To: Summey Engineering Associates
From: Jeff Walton, Associate Planner; 910-341-3260
CC: File;
Date: 1/11/2023
Re: Cookout – Market Street

The following is a list of comments for review from planning regarding the project. Please provide your corrections as listed below. A staff summary of comments:

Engineering has reviewed the plans for the Cookout Market Street project submitted December 12, 2022, for TRC review and have the following comments:

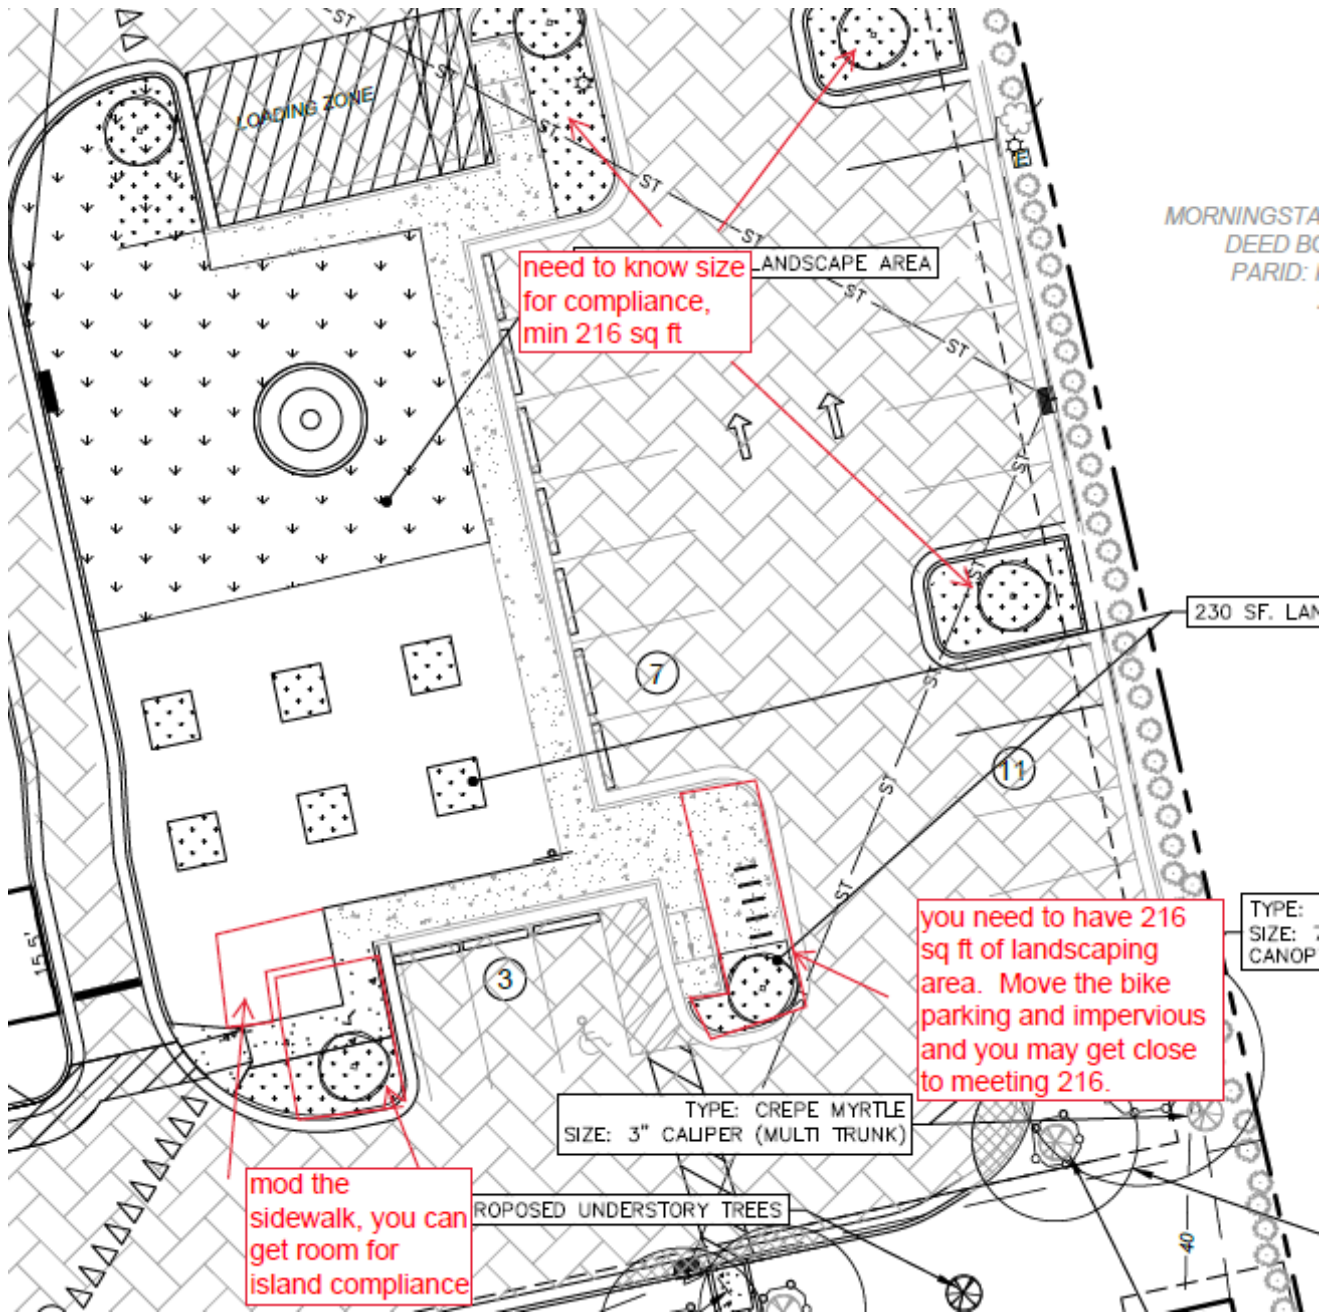
SIGHT DISTANCE TRIANGLE FOR ANY STREET/DRIVEWAY INTERSECTIONS WITH THOROUGHFARES

Market St is a major thoroughfare [Chap VII (C) (2) (a) of CofW Tech Stds]. In accordance with the City Code, sight distances along thoroughfares must be calculated in compliance with the AASHTO requirements. [Chap VII (C) (1) of CofW Tech Stds] [Sec.18-556 CofW LDC]. Show and callout AASHTO departure sight distances for driveway off Market St.

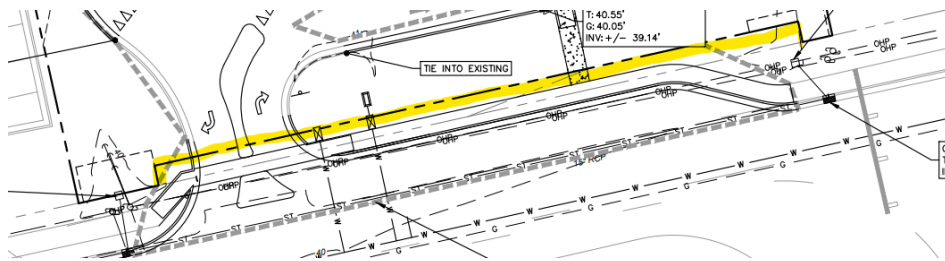
- All parking rows shall have 216 sq ft landscape islands at the end of each row.
 - I made some suggested redlines that may help in compliance. Next page

need to know size
for compliance,
min 216 sq ft

mod the
sidewalk, you can
get room for
island compliance

you need to have 216
sq ft of landscaping
area. Move the bike
parking and impervious
and you may get close
to meeting 216.
